STAFF RECOMMENDATION

NCPC File No. 6621

FORT LESLEY J. McNAIR,
ACCESS CONTROL POINT, EAST GATE
P and 2nd Streets, SW
Washington, D.C.

October 27, 2005

GUARD BOOTH AND ID CHECK AREA

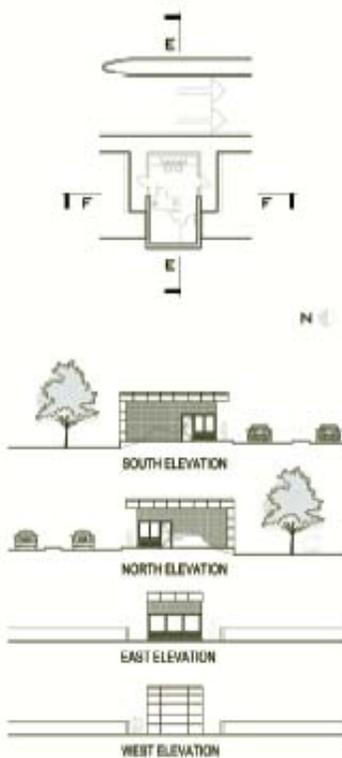
- The Army re-assess the use of the wide-edge precast concrete at the guardhouse and inspection station, and determine a narrower width to the roofline edges for implementation.
- The gate area, situated between the visitor center and the guard booth and identification check area, to be fully presented with the intermediate gates and posts illustrated and dimensioned completely.
- All gate cartway vehicle barriers to be located and identified in the final design.
- The Army continue to consult with NCPC staff, the staff of the Commission of Fine Arts, and the District of Columbia Office of Planning regarding the perimeter fence focal point at 2nd Street and Potomac Avenue, to ensure the design of this feature is suitable and appropriately proportioned.

Staff finds the submitted architecture of the five building facades maintains important elements of the visual focus toward material use and fenestration that gives a thematic relationship to all the features of the gate area. Nevertheless, staff recommends the design team re-assess the use of the wide-edge precast concrete at the guardhouse and inspection station to determine a more appropriate width to the roofline edges, and perhaps carry that revised dimension throughout. Additionally, staff believes the project area situated between the visitor center and the guard booth and ID check area should be fully presented, and the intermediate gates and posts should be illustrated and dimensioned completely. Staff also feels all vehicle barrier systems for the gate area traffic lanes must be indicated in the final project design. Lastly, staff recommends that the applicant continue to consult with NCPC staff, the staff of the Commission of Fine Arts, and the District of Columbia Office of Planning regarding the perimeter fence focal point at 2nd Street and Potomac Avenue, to ensure the design of this feature is suitable and appropriately proportioned.

TYPICAL CROSS SECTION AND PLAN OF FORT McNAIR EAST GATE PERIMETER AND AWI RIVERWALK FEATURES AT 2ND STREET, SW

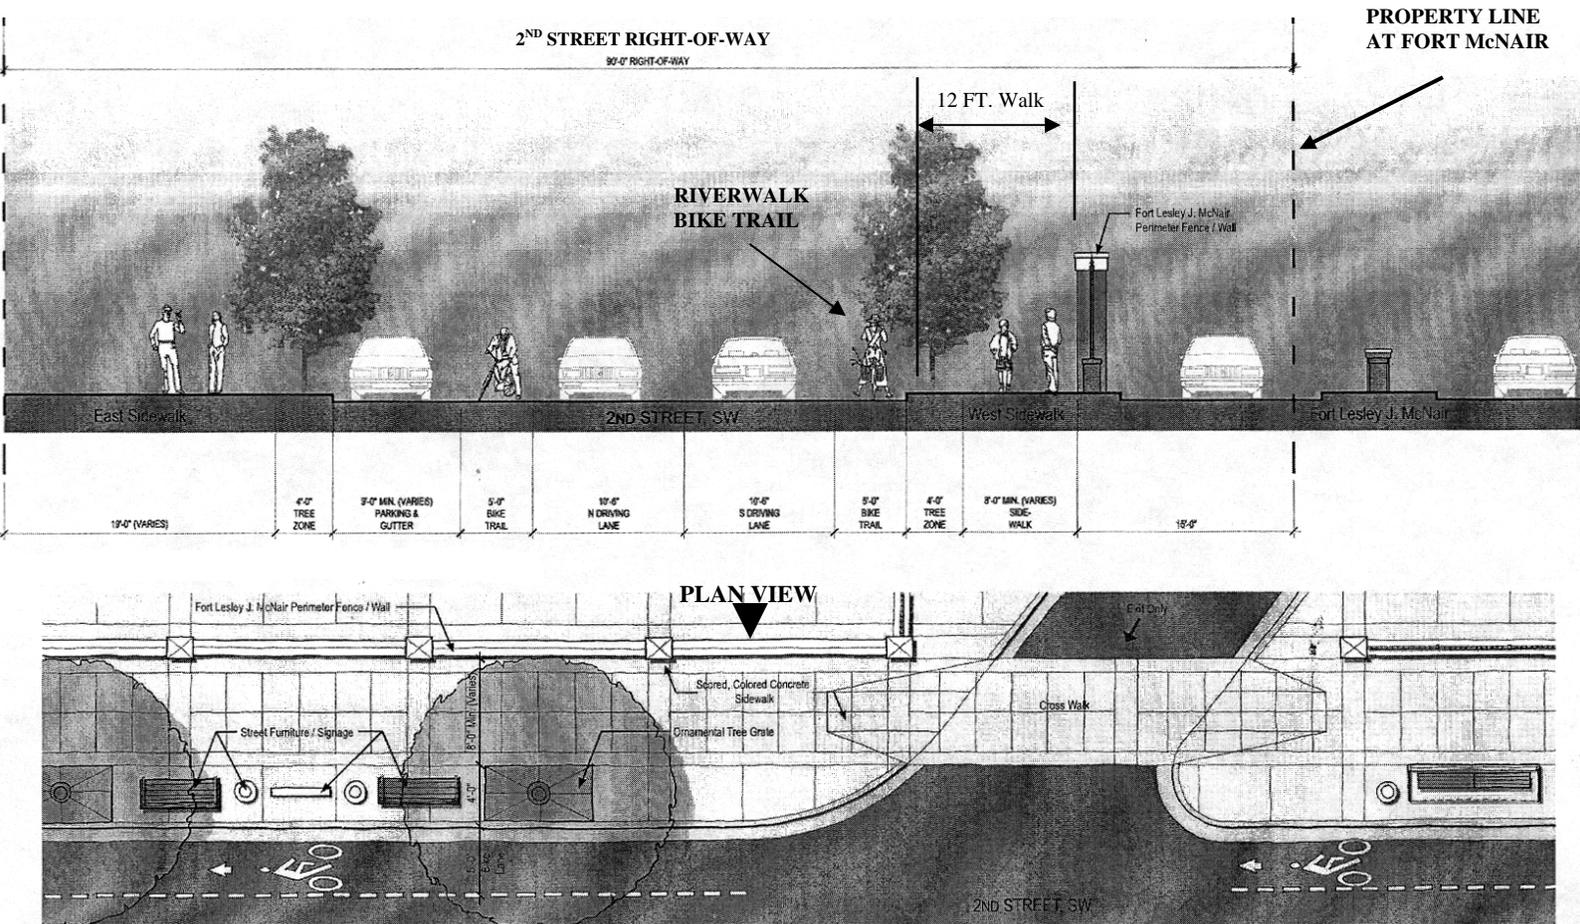
Previously, in November of 2004, the District of Columbia Office of Planning (DCOP) expressed the following important points regarding the establishment of a new gate at 2nd Street:

- The Army must consider actions that do not replicate the blank façade walls and buildings at the post along P Street. A varied and interesting street wall, with façade treatments and visual openings, would be a significant benefit.
- The emphasis that adjacent streets leading to any relocated gate be adequate to handle new traffic patterns and volumes, including pedestrian and bicycle access.
- That 2nd Street, SW, should be maintained as a segment of the Anacostia Riverwalk and Trail from P Street to the James Creek Marina at the end of 2nd Street. Any perimeter, gate entrance and base boundary realignment must accommodate the presence of the planned trail at the 2nd Street right-of-way.

The preliminary design of the new gate area responds to the issues by continuing to maintain an open space character to the secured perimeter and provides the open visual transparency desired by local planners. Additional landscape treatments occur beyond the fence adjacent to the new entrance road which provides a green space background to the boundary and minimizes the visual height of the security structures and thus softens the building mass impact.

SIMULATED VIEW OF PERIMETER FENCE FOCAL POINT ALONG 2ND STREET AT POTOMAC AVENUE

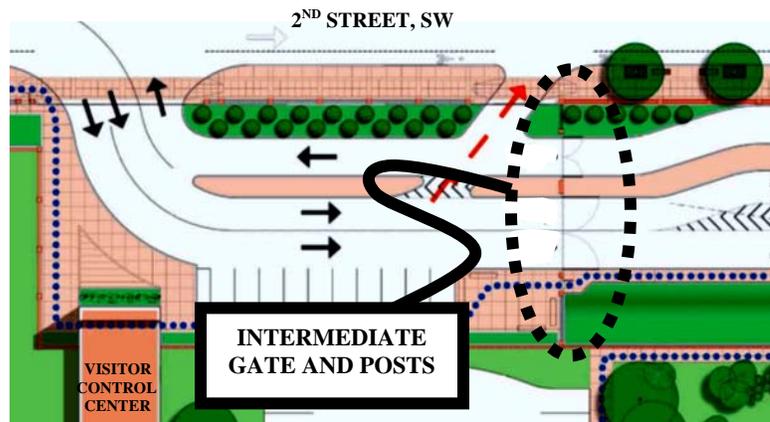
The Commission of Fine Arts reviewed the project as a concept for the facilities at 2nd and Q Streets, SW. The Commissioners approved the proposal, with a request for further review, and highlighted that the landscape treatments should be further evaluated to increase the height of the berming, if possible. Additionally, one Commissioner requested that the fence focal point on 2nd

Street, SW be re-considered and perhaps removed. The review comments endorsed the compact nature and low architectural profile of the buildings and commended the Army for the overall effort.
